HISTORIC LANDMARK COMMISSION STAFF REPORT

**Newhouse Apartments
New Construction
PLNHLC2012-00538
540 East 500 South
August 1, 2013**

Strategic Capital Group, represented by Adam Paul, requests the Historic Landmark Commission review and approve stucco as an exterior finish material on portions of the now under construction Newhouse Apartments at approximately 540 East 500 South. The design of the new building was approved by the Historic Landmark Commission at its December 6, 2012 regular meeting.

SIDE ELEVATIONS

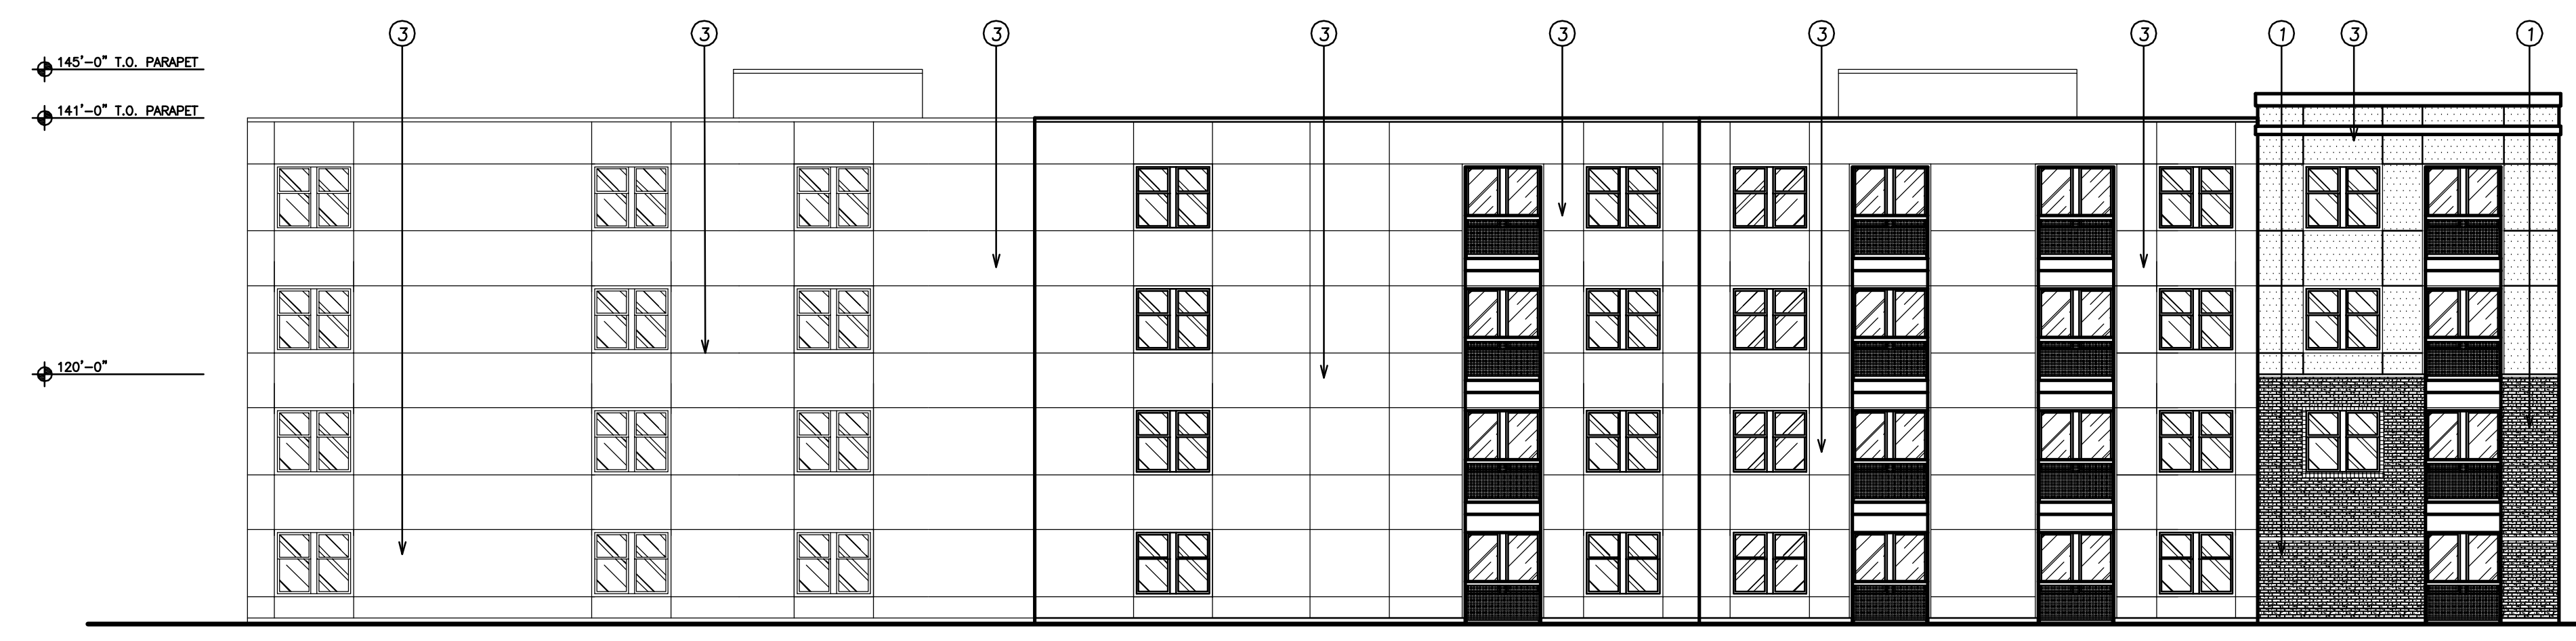
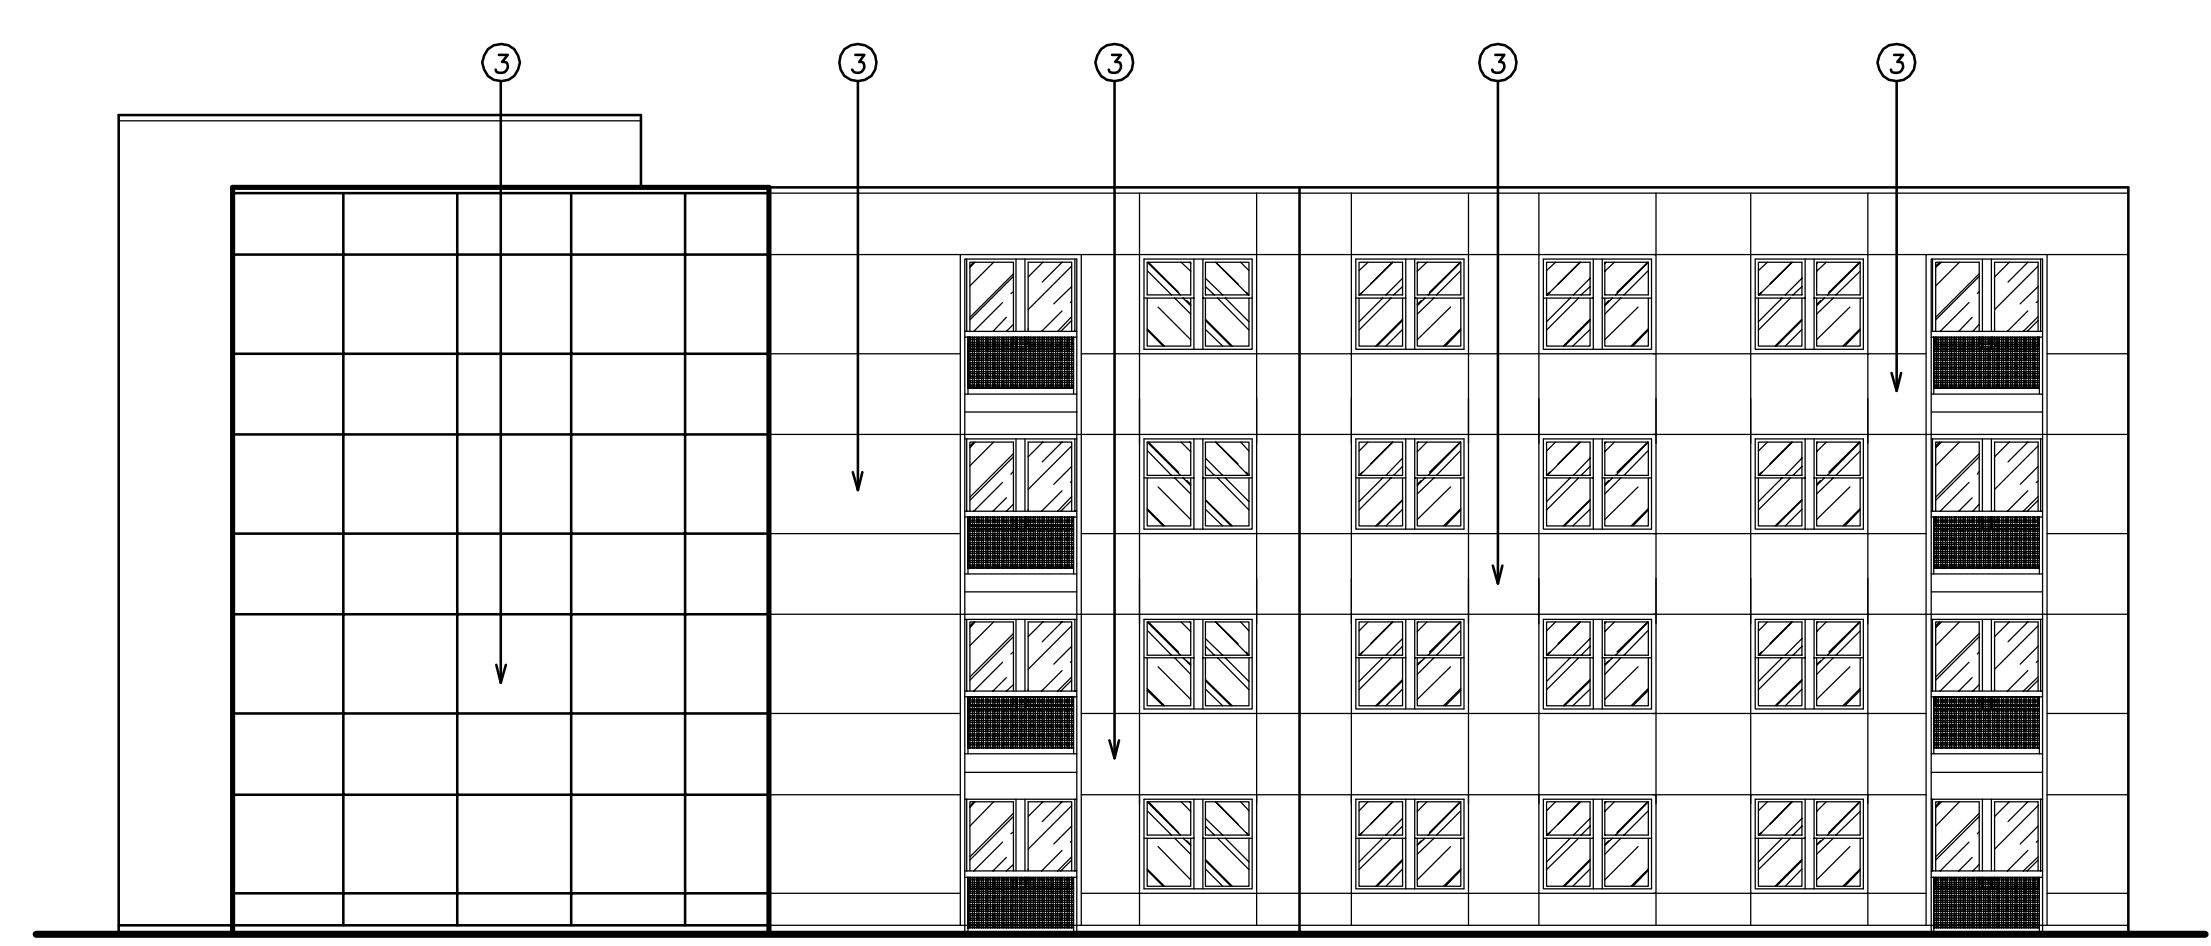
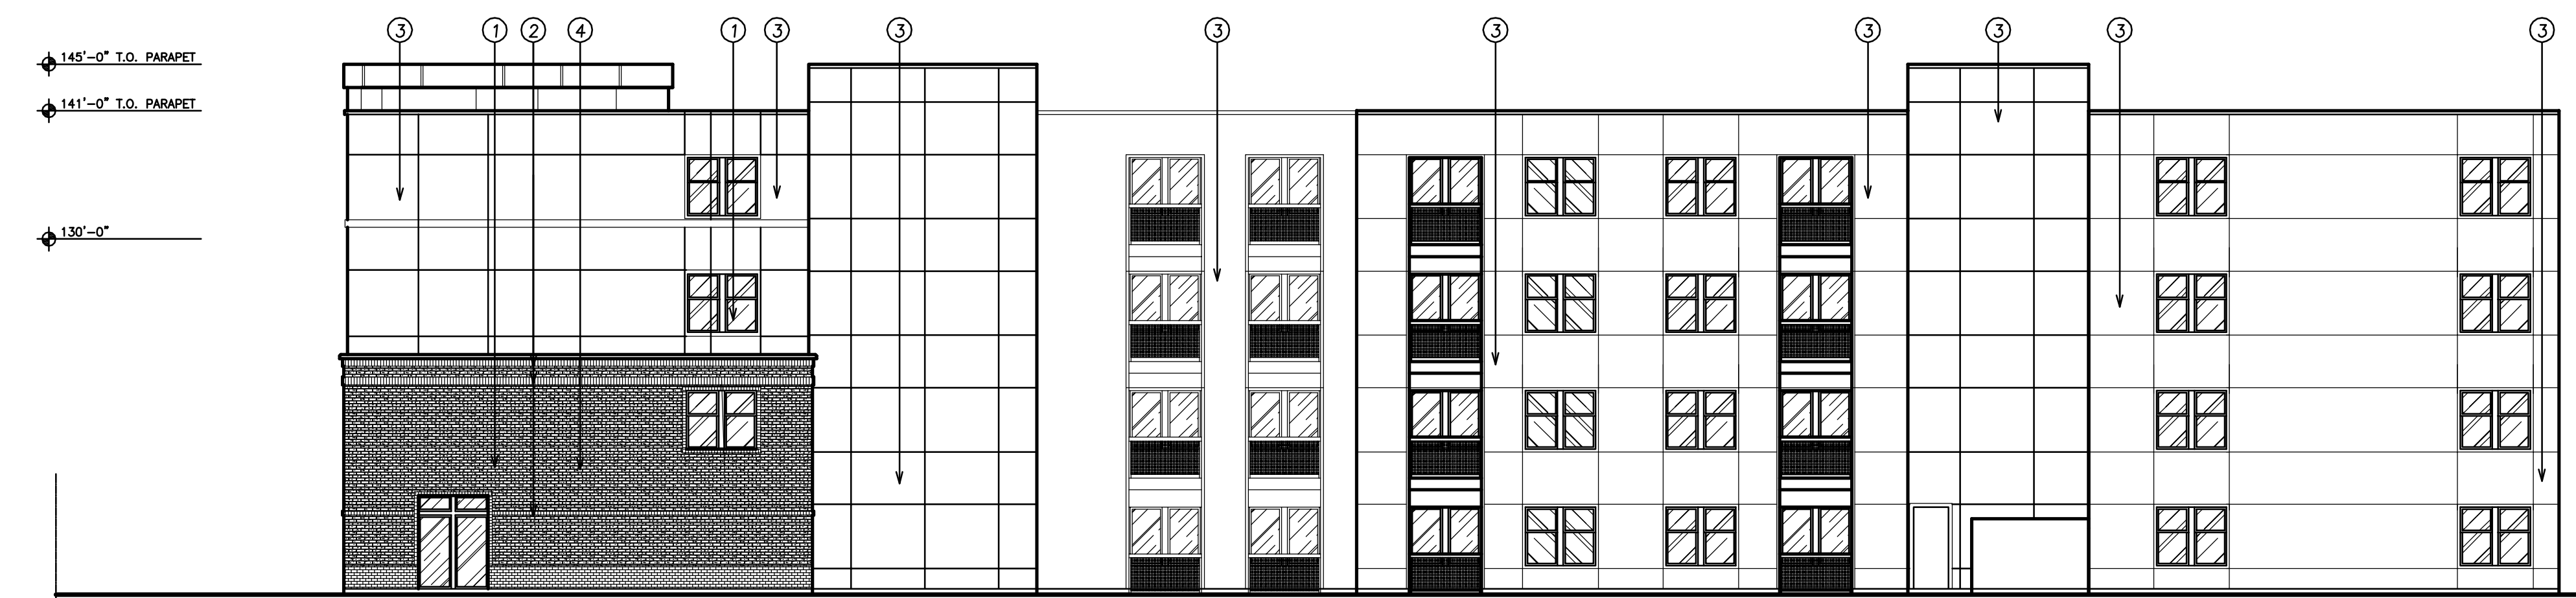
The applicant, Strategic Capital Group, seeks approval to use Quikrete One Coat Fiberglass Reinforced Stucco as an exterior building material in place of the previously approved Hardie panels. The applicant will maintain the proportion and location of brick previously approved by the Historic Landmark Commission. The Commission had approved the use of metal seams with the Hardie panels to create a shadow effect. The applicant wishes to keep the metal seams. The metal seams will become control joints in the proposed stucco.

The building approved by the Historic Landmark Commission was proposed to have exterior building materials of brick and Hardie panel. The front elevation was proposed to have an even mix of brick and Hardie panel while the side and rear elevations would be constructed wholly of Hardie panels. The Hardie panels would include a metal seam. (See Attachment C: Building Elevations).

Analysis: Stucco is a traditional building material for the Central City Historic District. The use of Quikrete One Coat Fiberglass Reinforced Stucco will allow the building to appear similar to other buildings in the district and on the block face.

The proposed Quikrete One Coat Fiberglass Reinforced Stucco appears to be more durable and require less maintenance than the previously approved Hardie panels. Staff has visited 644 West North Temple and agrees with the applicant that the Hardie panels have a poor appearance up close. Stucco, if applied correctly, should have a better appearance.

I have received the notice that the project on 540 E 500 S intends to request a change from Hardi Panel to Stucco. I am concerned that this will make the project look cheap and clash with the historic nature of the area. I would like the board to hold them to their initial proposal of hari panel.

- The material shall be applied only to those areas indicated on the plans attached to this staff report.

Finding: Quikrete One Coat Fiberglass Reinforced Stucco is a traditional building material for the Central City Historic District. The substitution of stucco for Hardie panels will generally meet Standard 2.
